CNL-17-099 CRN RAI Response Number 5 and 6

Clinch River Nuclear Site  
NRC Docket No. 52-047

Subject: Response to Request for Additional Information Number 5, Questions 02.05.01-01 and 02.05.01-02, Regarding Basis Geologic and Seismic Information and RAI Number 6, Questions 02.05.04-01 and 02.05.04-02, Regarding Stability of Subsurface Materials and Foundations in Support of Early Site Permit Application for Clinch River Nuclear Site

Figure 2.5.3-21. Geologic Field Reconnaissance Waypoint Locations along Tellico Reservoir

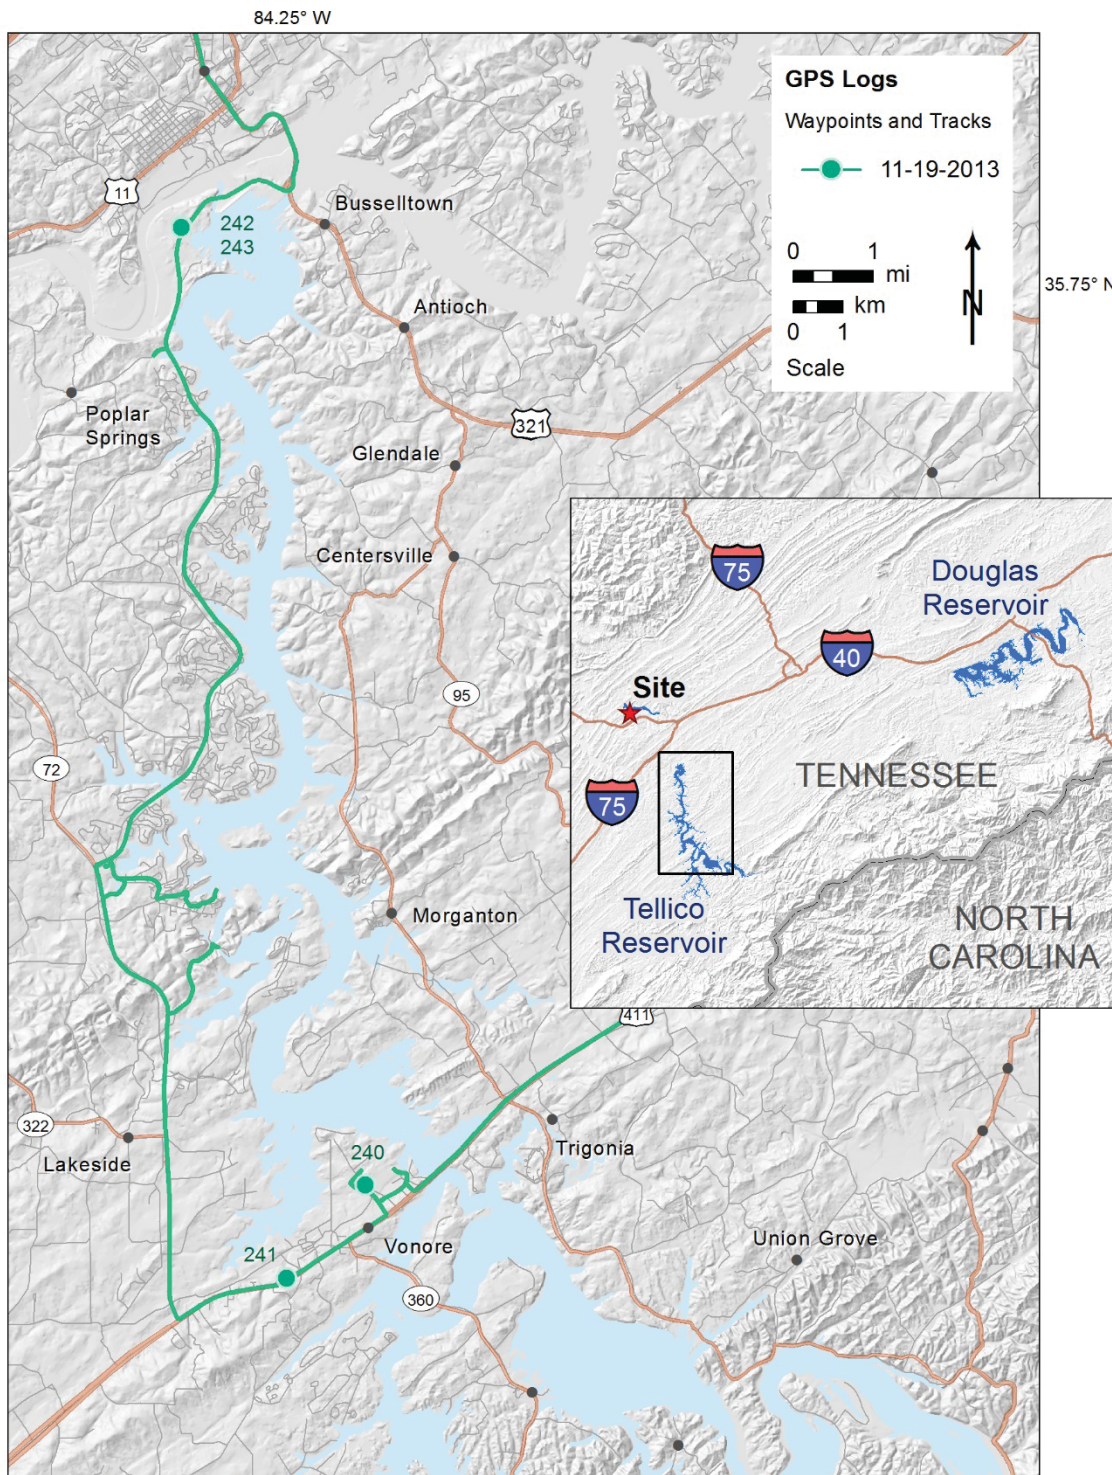
*The presence of paleoliquefaction features is a potentially significant contributor to the demonstration of compliance with 10 CFR 100.23 (c-d). Because insufficient paleoliquefaction feature data were included in the SSAR (Rev 0) sections associated with the Watts Bar and Tellico Reservoirs, please provide details regarding the specific investigation of the paleoliquefaction evaluation within the 25 mile radius of the CRN site. In particular, provide the field reconnaissance information obtained along the Clinch River arm of the Watts Bar and Tellico Reservoirs and provide the associated relevant source documentation.*

Near the Fort Loudon Dam and along the Little Tennessee River, a sequence of terraces, T6, T7, and T9 (as mapped by Delcourt, Reference 2.5.3-24), was observed (Waypoints 240, 242, 243, Figure 2.5.3-21). The T8 terrace does not appear to be preserved in this area. The T6 and T7 terraces were easily distinguishable by their near-horizontal, planar treads (Figure 2.5.3-22A) with relatively small (approximately 1- to 2-m-high) sharp risers. Extensive exposures of the 4-m-high riser between the T7 and T9 treads include well rounded gravel horizons interbedded with strongly oxidized reddish sandy clay terrace deposits (Figure 2.5.3-22B). T9 terrace deposits appear to be approximately 3 to 4 m thick. Small gravel-rich fans emanating from T9 and deposited on T7 were evident. No evidence of potential paleoseismic features, such as fractures, clastic dikes, or paleoliquefaction, was found in these terrace deposits.

Figures 2.5.3-21 and 2.5.3-22 are being added to SSAR Subsection 2.5.3

**Figure 2.5.1-21. (Sheet 1 of 2) Current Compressive Stress—Eastern United States**

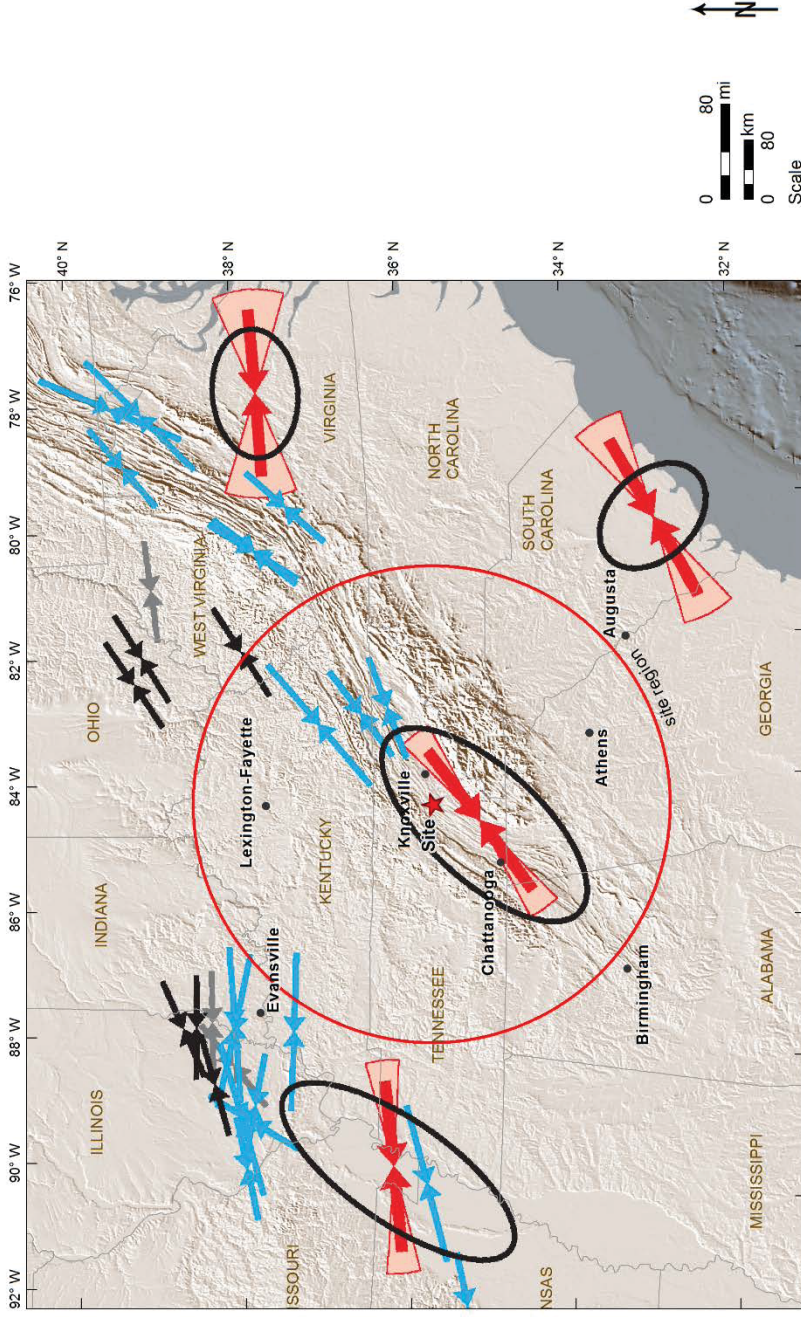
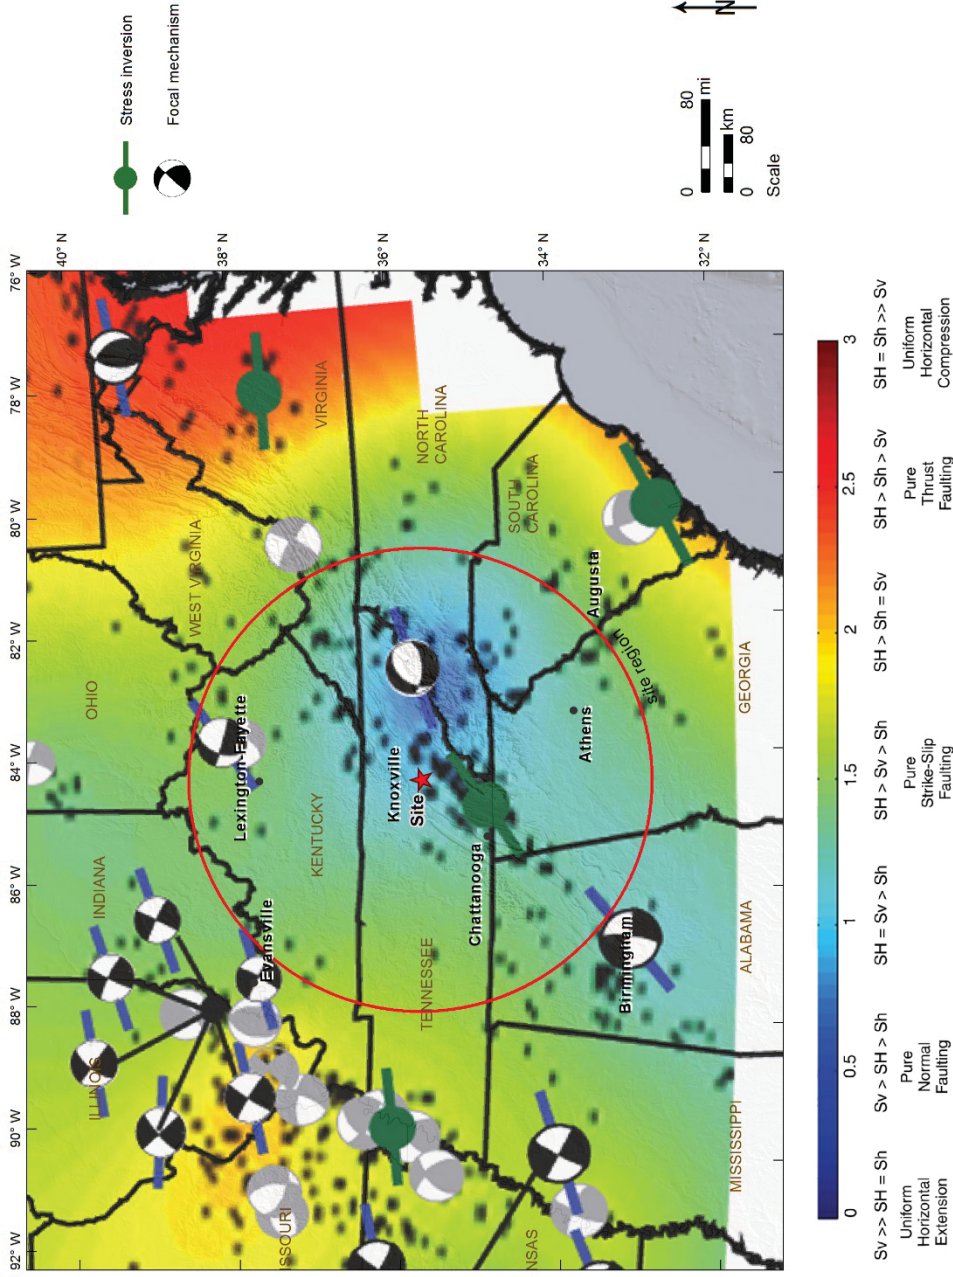
*Residual Stresses in Bedrock*

Hurd and Zoback (Reference 2.5.1-306) use the inversion results of Mazzotti and Townend (Reference 2.5.1-185), with an updated catalog of available earthquake focal mechanisms, to produce a map of the regional variation stress-field geometry (Figure 2.5.1-21, Sheet 2 of 2). They report a strike-slip focal mechanism from a  $M_w$  3.8 earthquake that occurred in 2009 in central Alabama approximately 350 km south of the CRN Site, which indicated left-lateral slip on a sub-vertical, WNW-ESE-striking nodal plane (alternatively, right-lateral slip on a NNE-SSW plane). The P-axis for this focal mechanism trends approximately N50°E, which is consistent with the inferred regional NE-SW trend of  $\sigma_1$  in the mid-plate stress province, and the inferred strike-slip kinematics suggest that  $\sigma_2$  is vertical and  $\sigma_3$  is horizontal in the vicinity of the earthquake.

A second sheet, Sheet 2, is being added to existing SSAR Figure 2.5.1-21. The title of Figure 2.5.1-21 (Sheet 1) is updated accordingly:

**Figure 2.5.4-27.2.5.4-27. Finite Element 2D Model of Foundation**  
**Location A, Cross Section: A-A'**  
**Cavity Diameter: 15 ft, Embedment Depth: 90 ft**  
**Cavity Location: 30 ft Below Edge of Common Basemat, Bedding Plane, Shear Joint Interface**

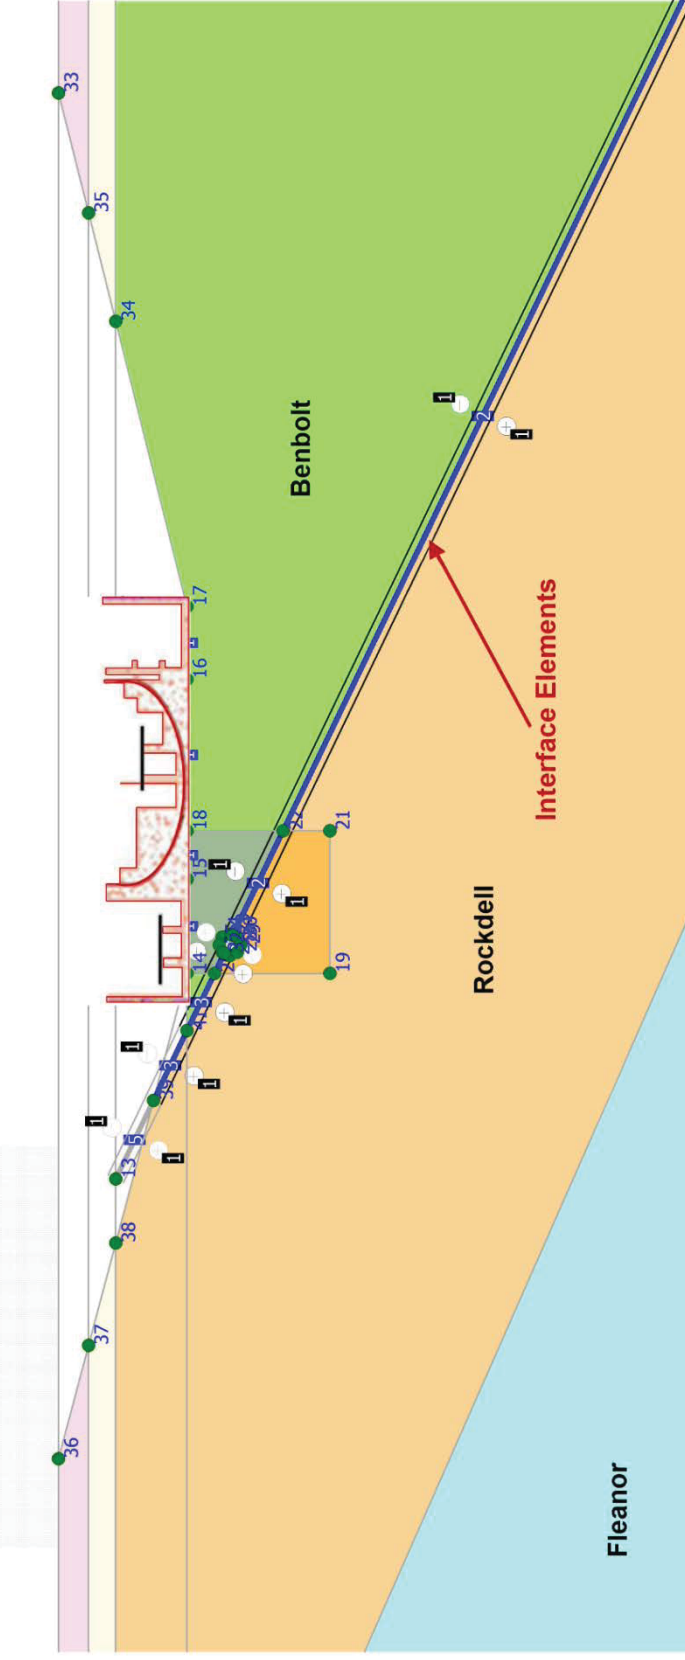
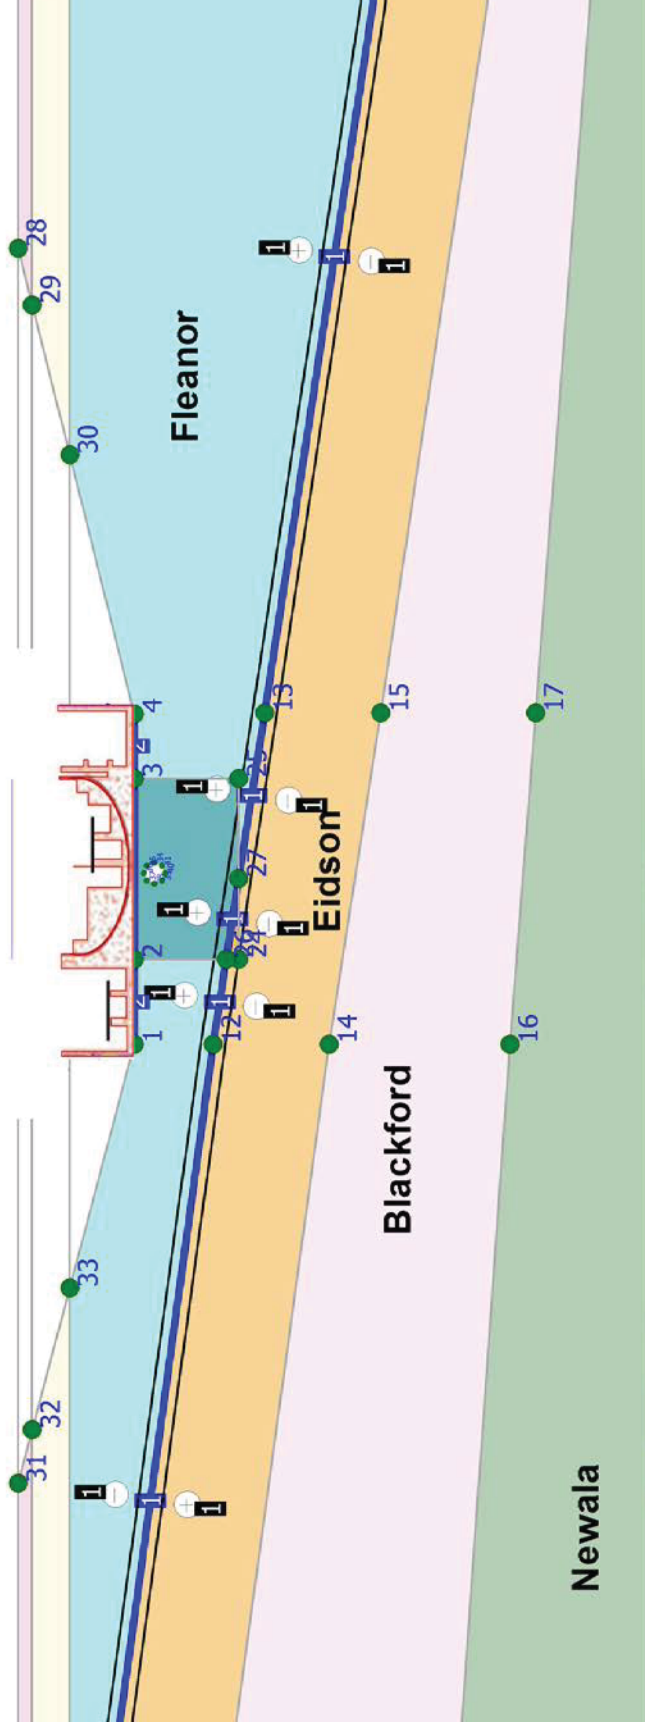
In SSAR (Rev 0) Section 2.5.4.2.4.4, it states that the rock mass properties are developed using the Geological Strength Index (GSI) classifications of the stratigraphic units. The site investigation data indicates the presence of rock discontinuities and fractures in the stratigraphic units, and the weathered or fracture zones typically occur along bedding planes at the CRN sites (SSAR 2.5.1.2.6.3 “Fracture Zones”). The rock mass discontinuities and fracture zones may result in pre-determined shear failure surfaces. Because the GSI chart may not be applicable when structural planes of the rock control the failure of rock mass [Ref.1], and the rock mass property is a key input for the evaluations of foundation stability, please discuss how the inclined rock formation interfaces were taken into account when determining the rock mass properties to ensure the proper evaluations of subsurface material and foundation stability to meet the requirements of 10 CFR 100.23 (d)(4).

References 1 and 2 provide a PLAXIS finite element 2D model that applies uniform Mohr-Coulomb strength parameters to the inclined site stratigraphy. Using “interface elements” with lower strength values, this model considers a weakened zone along or near geologic formation or member contacts, specifically the Benbolt-Rockdell formation contact and the Eidson-Fleanor member contact, as shown in SSAR Figures 2.5.4-27 and 2.5.4-28. The lower strength is intended to “represent the properties of bedding plane discontinuities (e.g., weathered bedding plane joint zones) and shear fracture zones along stratigraphic contacts for both Site A and Site B” (Reference 2, p. 46). Use of lower strength “interface elements” makes the analysis more

The titles and notes to the following Figures, added by TVA letter CNL-17-082, are being revised as shown. Underlines indicates text to be added. Strikethroughs indicates text to be deleted.
